Technical Bulletins Sorted By Bulletin Number
Generated 02/28/92

DATE: March 4, 1985
REVISION DATE: March 4, 1985
BULLETIN NO.: 200:1
PRODUCT: 26-3860 (Model 200)
SUBASSEMBLY: Main Logic PCB

DATE: March 14, 1985
REVISION DATE: July 15, 1986
BULLETIN NO.: 2000:2
PRODUCT: 26-3860 Tandy 2000
SUBASSEMBLY: AXX-7103 Nicad Upgrade Kit
SUBASSEMBLY REVISION: All Revisions

DATE: August 5, 1986
REVISION DATE: August 5, 1986
BULLETIN NO: 2000:3
PRODUCT: 26-3860 Tandy 200
SUBASSEMBLY: AX-9505 Memory board
SUBASSEMBLY REVISION: A11

Figure 1. Memory PCB.

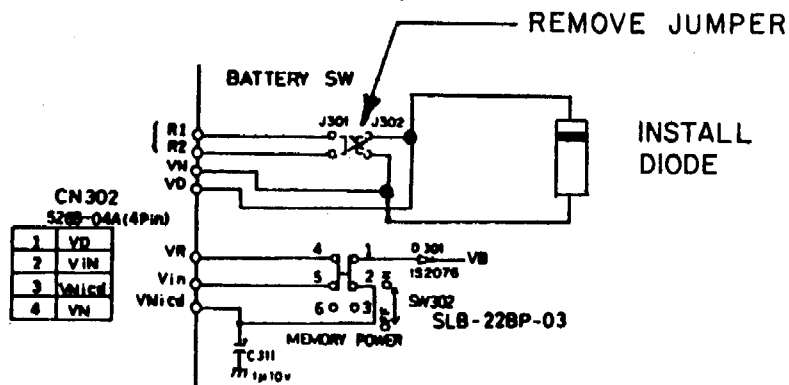
On the memory board of the computer, two jumpers were installed during the Ni-Cad upgrade (J301 and J302). Referring to figure 1 of the Memory PCB, remove the jumper wire J302 and in its place install a 1N914 diode. Note the proper orientation of the diode, the cathode (banded) end should be near the silkscreen J302 label. Because of the space restrictions, trim the diode leads short and check for any solder or wire shorts.

1N914 diode National Parts # DX-0010

Figure 2. Power Supply Section of Main PCB.

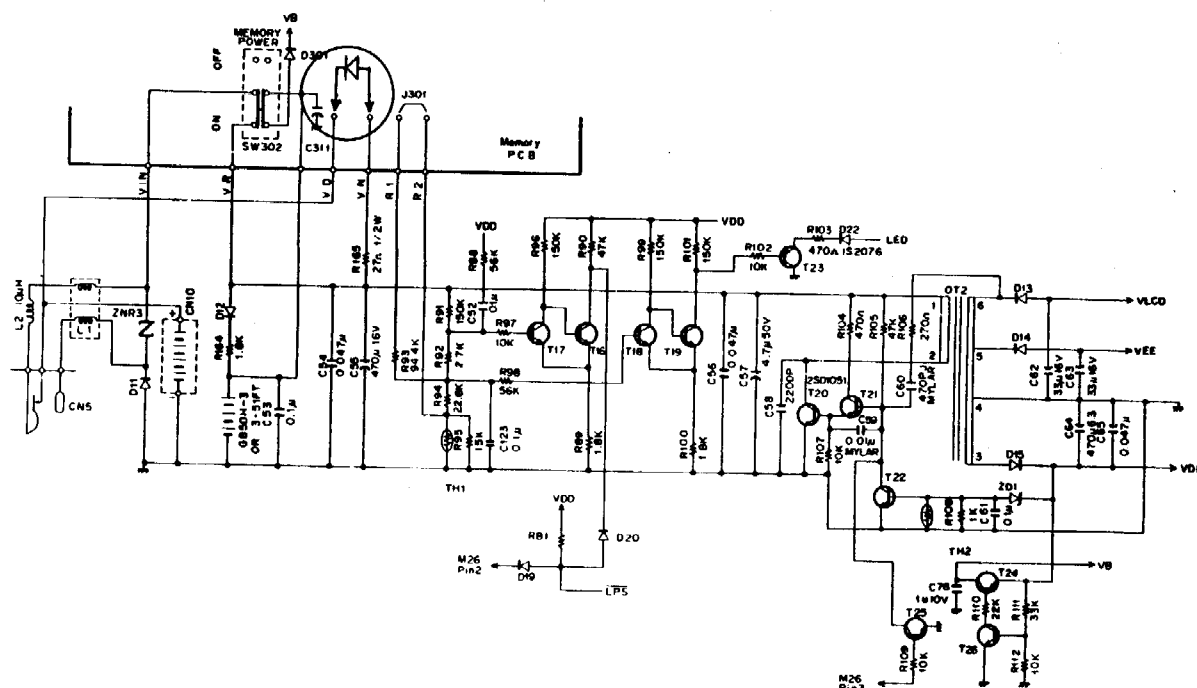
A problem has shown up while using the Tandy 200 with the Ni-Cad upgrade and an AC adapter. If AC power is lost and the customer pushes the ON/OFF button before removing the adapter plug from the computer, the unit will lock up tight even if he later removes the adapter plug. This problem can be corrected by installing a 1N914 diode between the Ni-Cad batteries and the AC source.

Figure 2 is the power supply section of the main pcb. It shows the schematic change involved with this procedure.
